**ENCLOSURE**  
**Evaluation of Proposed Change**

License Amendment Request: Technical Specification Revision to Adopt WCAP-14483-A,  
Generic Methodology for Expanded Core Operating Limits Report

The proposed amendment would revise the Technical Specifications for Vogtle Electric Generating Plant (VEGP) Units 1 and 2 renewed facility operating licenses NPF-68 and NPF-81, respectively.

Figure 2.1.1-1  
Reactor Core Safety Limits

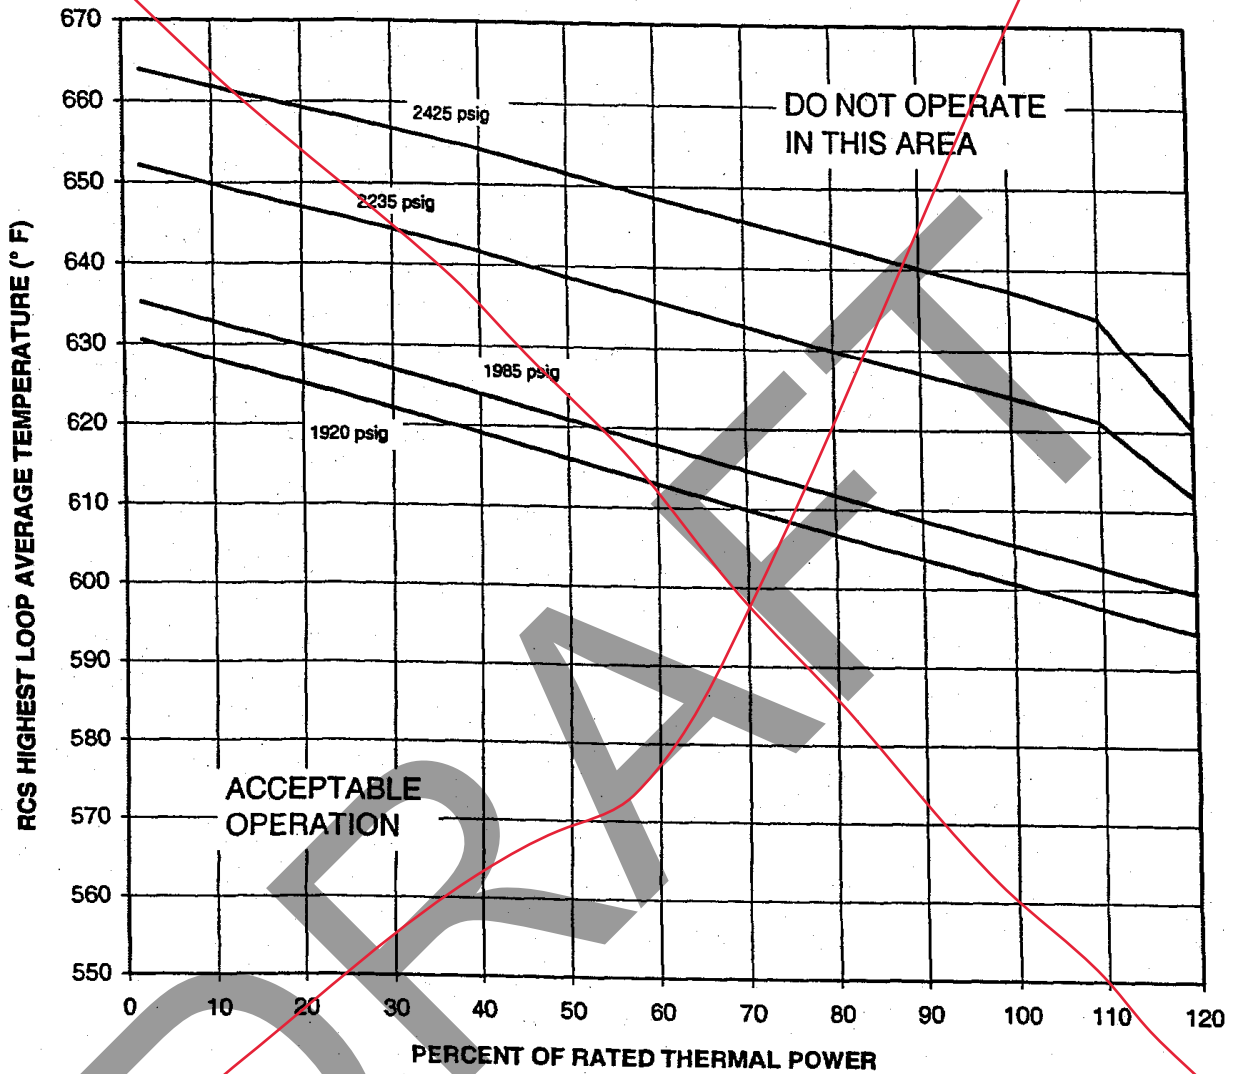
- The Figure showing the limiting combinations of THERMAL POWER, RCS highest loop average temperature, and pressurizer pressure is moved to the COLR.
- Safety Limits are added for the DNB ratio and for peak fuel centerline temperature.

Remove this figure.

Table 3.3.1-1 (page 9 of 9)  
Reactor Trip System Instrumentation

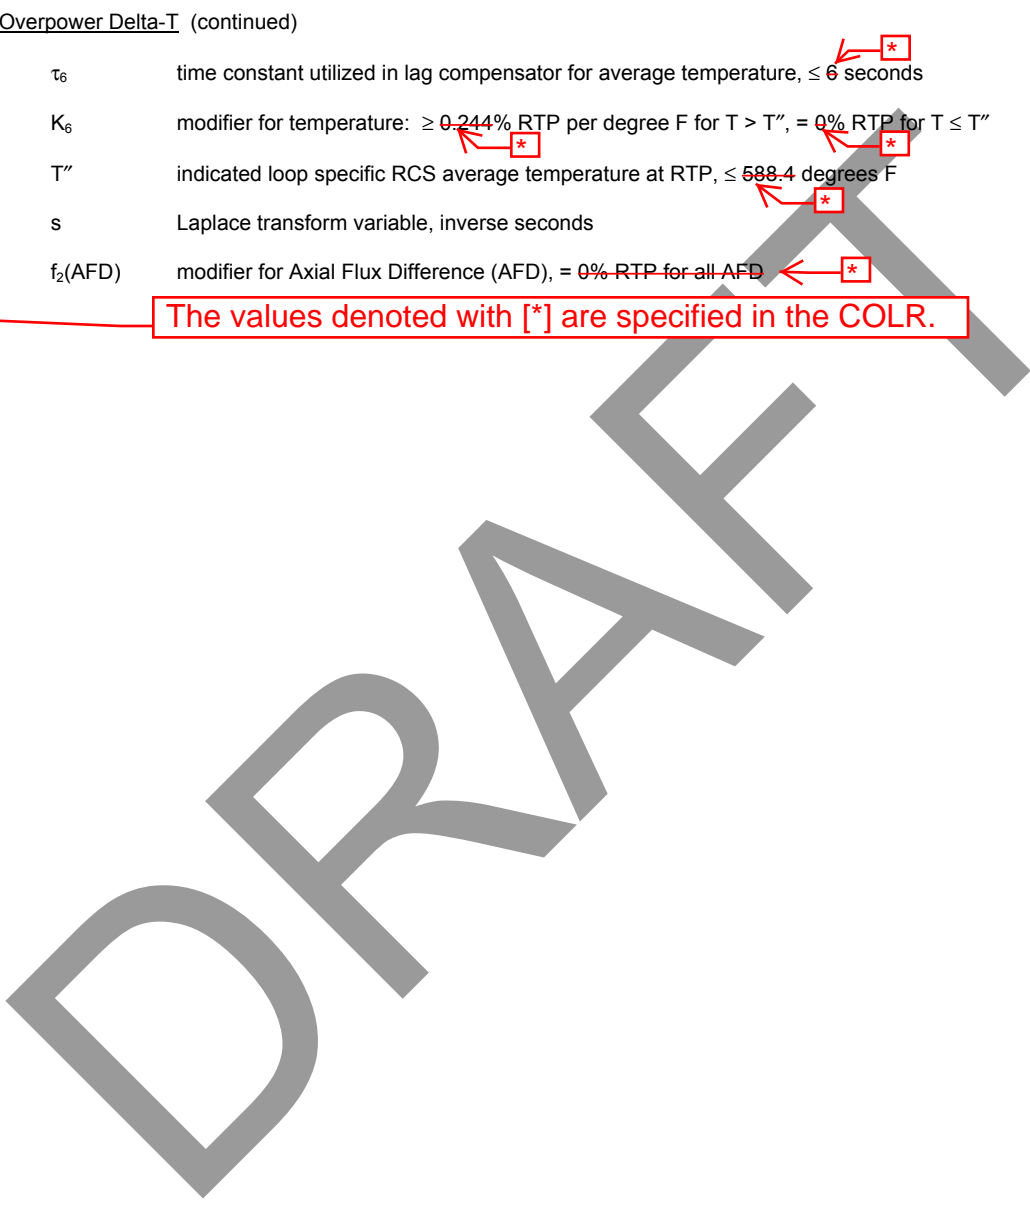
- Table 3.3.1-1 Note 2 related to the OPΔT Function

Several parameter values are moved from the TS to the COLR including:

The values for each of these parameters is replaced with an asterisk [\*] and a Note is included following the listing of parameters identifying that the asterisk denotes the value is specified in the COLR.

The values denoted with [\*] are specified in the COLR.

Figure B 2.1.1-1 (page 1 of 1)  
REACTOR CORE SAFETY LIMITS VS. BOUNDARY OF PROTECTION

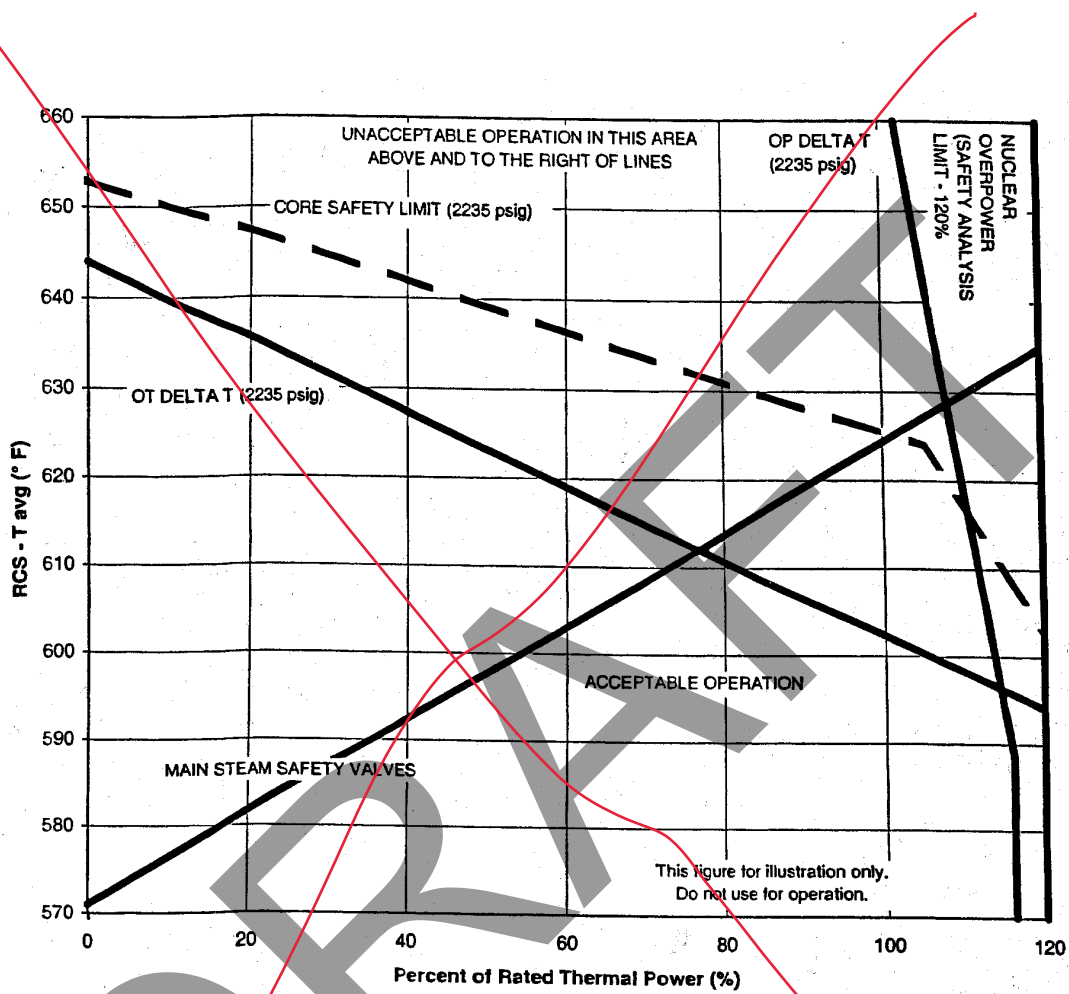
Remove this figure.

FIGURE 7  
REACTOR CORE SAFETY LIMITS

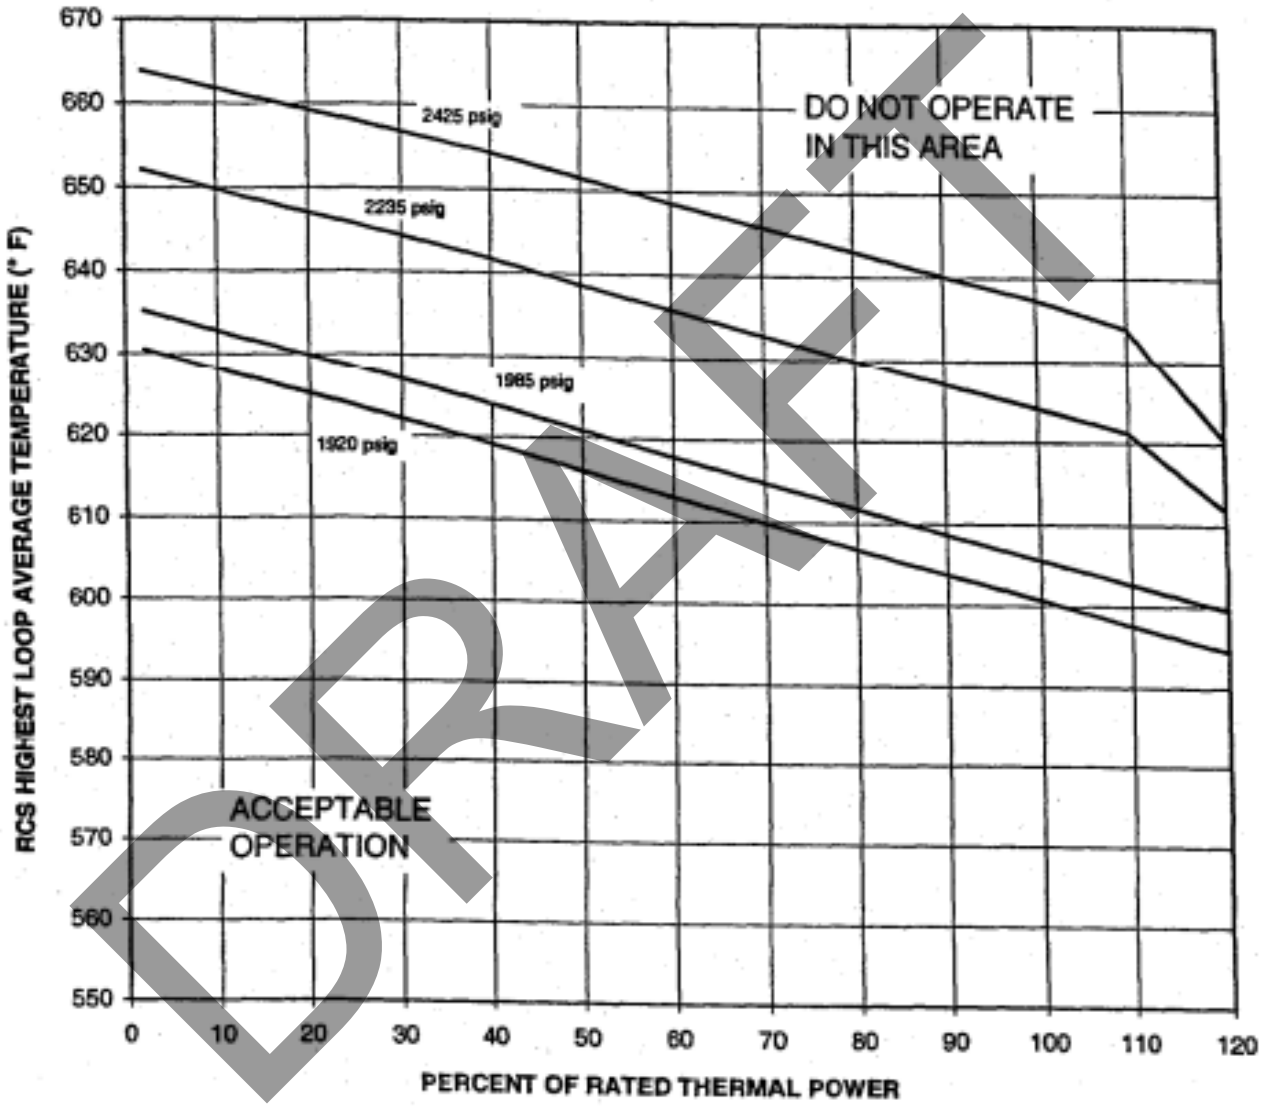
2.10.1 In MODES 1 and 2, the combination of THERMAL POWER, Reactor Coolant System (RCS) highest loop average temperature, and pressurizer pressure shall not exceed the safety limits specified in Figure 7.

INSERT 5 for new COLR Figure 7
